Working Party on Noise and Tyres

Tyres: UN Regulation No. 54 (Tyres for commercial vehicles and their trailers)**Proposal for amendments to UN Regulation No. 54****Submitted by the experts from the European Tyre and Rim Technical Organization***

The text reproduced below was prepared by the experts from the European Tyre and Rim Technical Organization (ETRTO). The modifications to the existing text of the UN Regulation are marked in bold for new or strikethrough for deleted characters.

Annex 3, Figure, replace and amend to read:

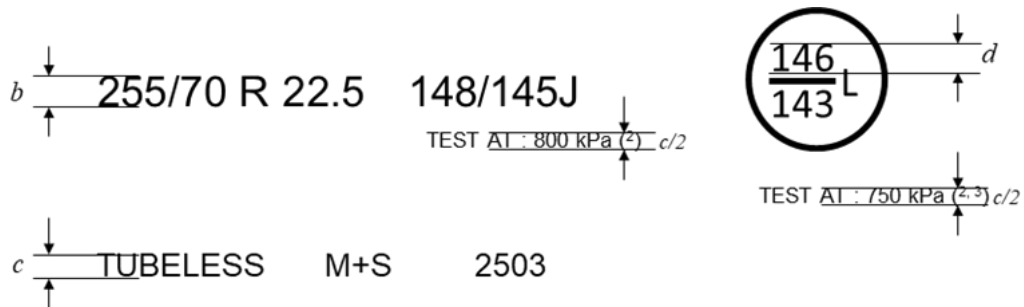
"Example 1:

- (1) PSI marking instead of kPa is allowed for tyres first type approved before 1 January 2018. **The kPa marking may be preceded by "TEST AT : " or, alternatively, by "TEST INFL : " or the symbol "@".**

Example 2:

- (2) "TEST AT : " may be replaced by "TEST INFL : " or the symbol "@" or be omitted.
- (3) The indication of a second inflation pressure for the additional service description is optional. If there is no indication, the same test inflation applies to both load/speed combinations.

- (4) For "ML" and "MPT" being part of the tyre size designation marking the minimum dimension *b* applies."
